State of Louisiana

Department of Health
Office of Public Health

Re: Class I Sanitary Survey
Village of Estherwood Water System
PWS ID #: LA 1001003
Acadia Parish

Attachment #4

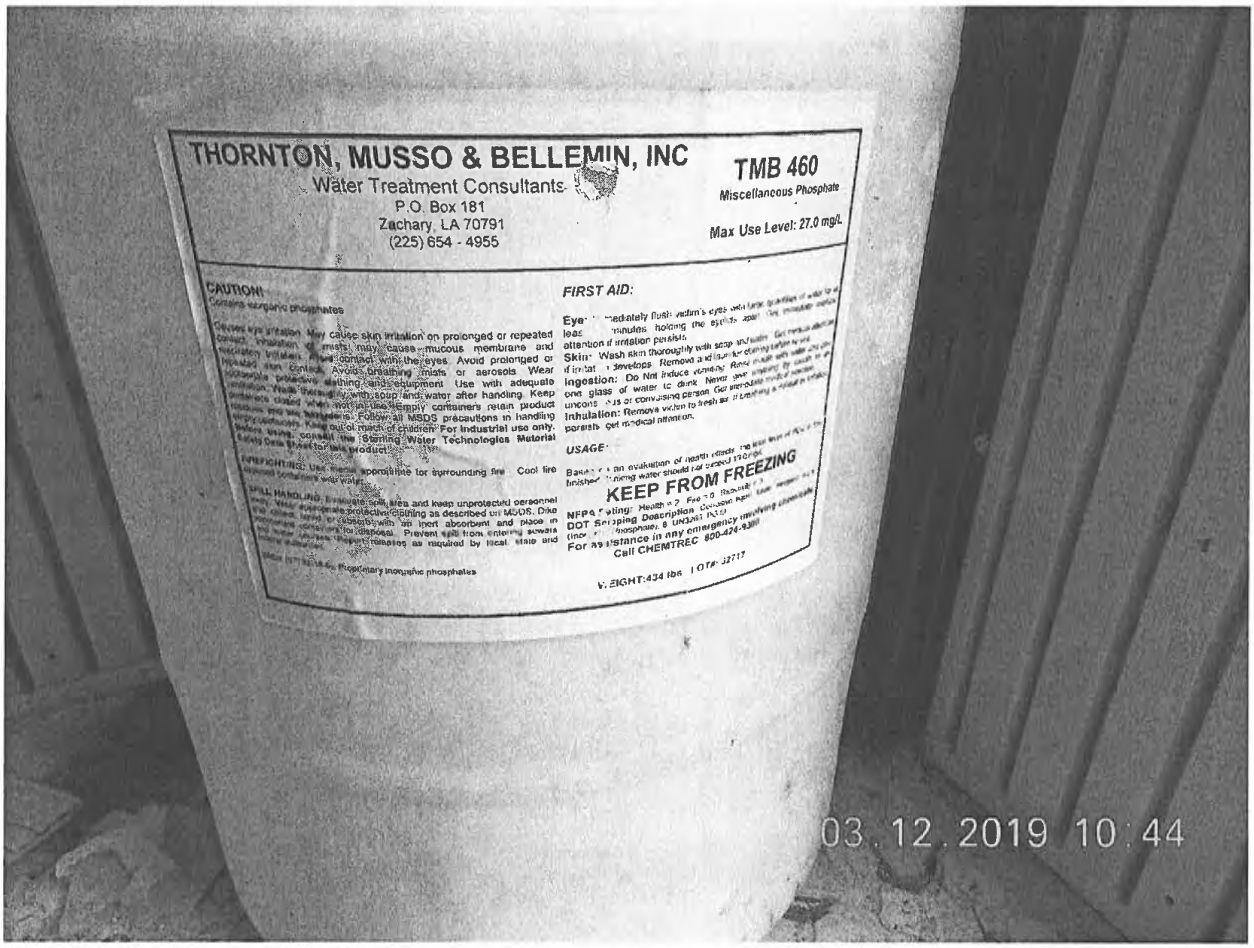
Attachment Comments: The sequestration of iron and manganese with polyphosphates must be monitored by testing for phosphates.
